AGENDA SECTION: PUBLIC HEARINGS	ORIGINATING DEPT: PLANNING	ITEM NO. E-14
ITEM DESCRIPTION: Final Plat #03-06 by Elton Hills Plaza West, LLC to be known as 41 <sup>st</sup> Street Business Park		PREPARED BY: Brent Svenby, Planner

**RE: Final Plat #03-06 to be known as 41<sup>st</sup> Street Business Park.**

The Department of Public Works has reviewed the application for a Final Plat #03-06 on the proposed 41<sup>st</sup> Street Business Park property. The following are Public Works comments on this request:

# 41ST STREET BUSINESS PARK

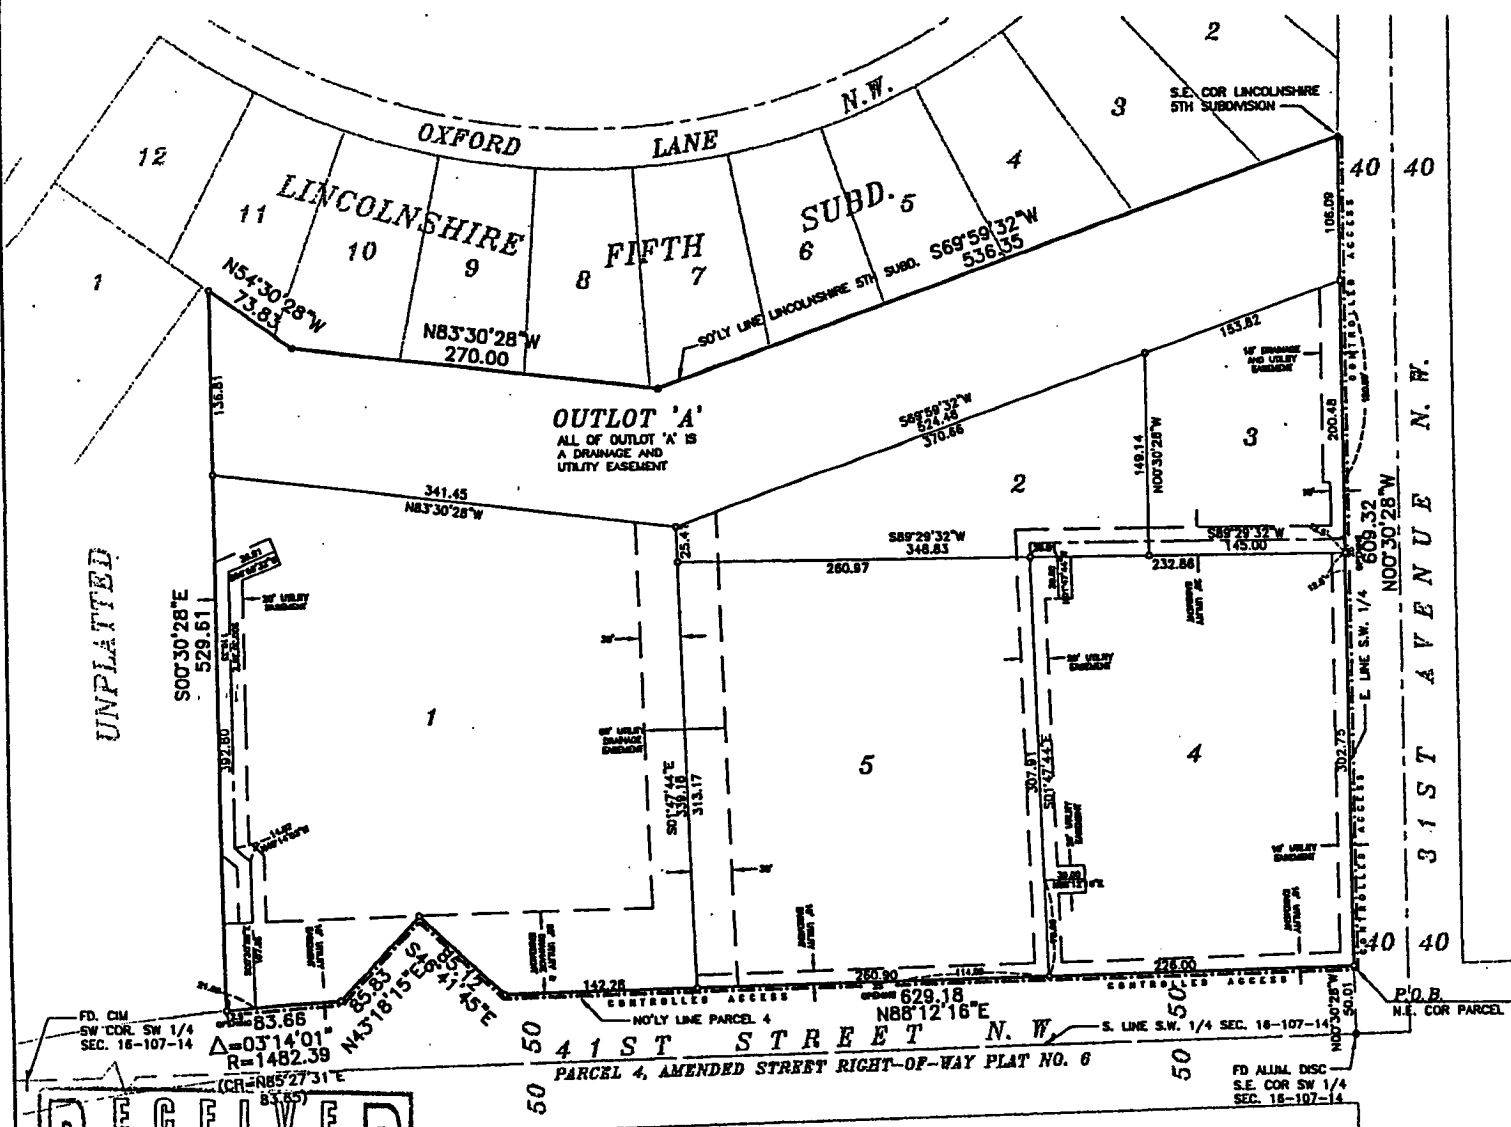
1. ***Cross access easements must be provided over the private road system. Said easements must be recorded concurrent with the final plat documents.***
2. ***Prior to the recording of the final plat documents, the final grading and drainage plans shall be approved by the City Public Works Department.***
3. ***Prior to the recording of the final plat documents, the owner shall execute an Ownership and Maintenance Declaration for Outlot A.***
4. ***The applicant must provide surety that guarantees that the site will be fully restored, after completion of the excavation activity, to a safe condition, and one that permits reuse of the site in a manner compatible with the Comprehensive plan, neighborhood plans, and Land use Plan and applicable City policies. Said surety must be provided prior to commencement of grading activities on this property.***

Our review of the referenced final plat is complete and we have no objections, per the preliminary utility plan review, final utility plans have yet to be reviewed.

GRADING PLAN  
41ST STREET BUSINESS PARK  
ROCHESTER, MN

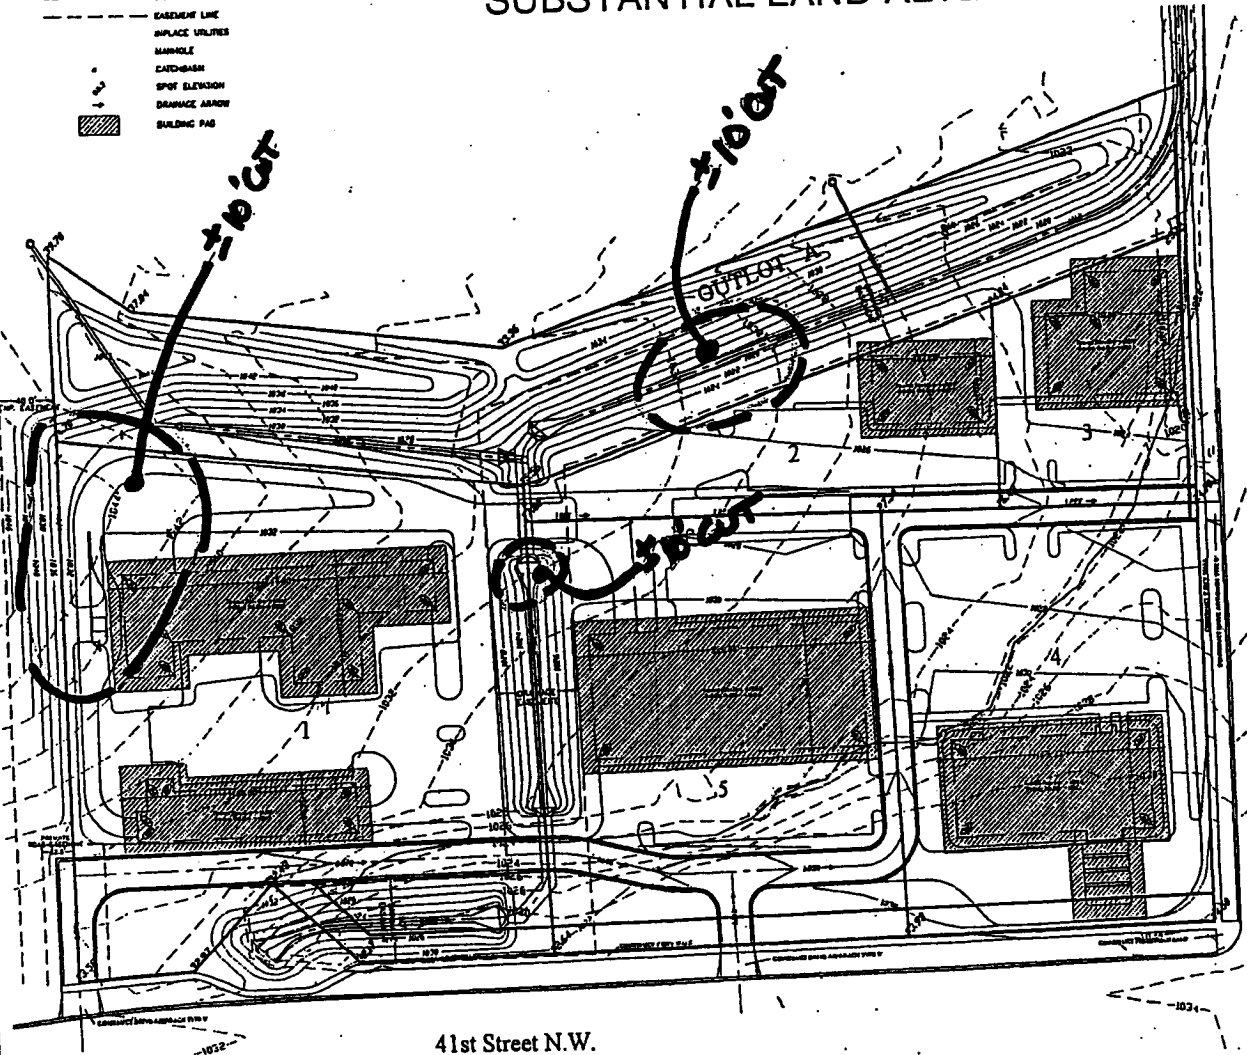
The applicant is requesting approval for grading work that includes altering grades by 10 feet or more in three locations on the property. The attached plan identifies the three areas that will exceed 10 feet of grade change. Please see the attached plan and narrative prepared by McGhie & Betts, Inc.

- #13) The grading and drainage plans and erosion and sedimentation control plans must be approved by the City prior to commencement of grading activities on this property.*

#14) *The applicant must provide surety that guarantees that the site will be fully restored, after completion of the excavation activity, to a safe condition, and one that permits reuse of the site in a manner compatible with the Comprehensive plan, neighborhood plans, and Land use Plan and applicable City policies. Said surety must be provided prior to commencement of grading activities on this property.*

- 1) *Not applicable.*
- 2) *Not applicable.*
- 3) *Not applicable.*
- 4) *The Rochester Public Works Department will need to review and approve the grading and drainage plan for this work. This plan must accommodate permanent and interim erosion and sediment control.*
- 5) *Not applicable.*
- 6) *Not applicable.*
- 7) *Not applicable.*
- 8) *Not applicable.*
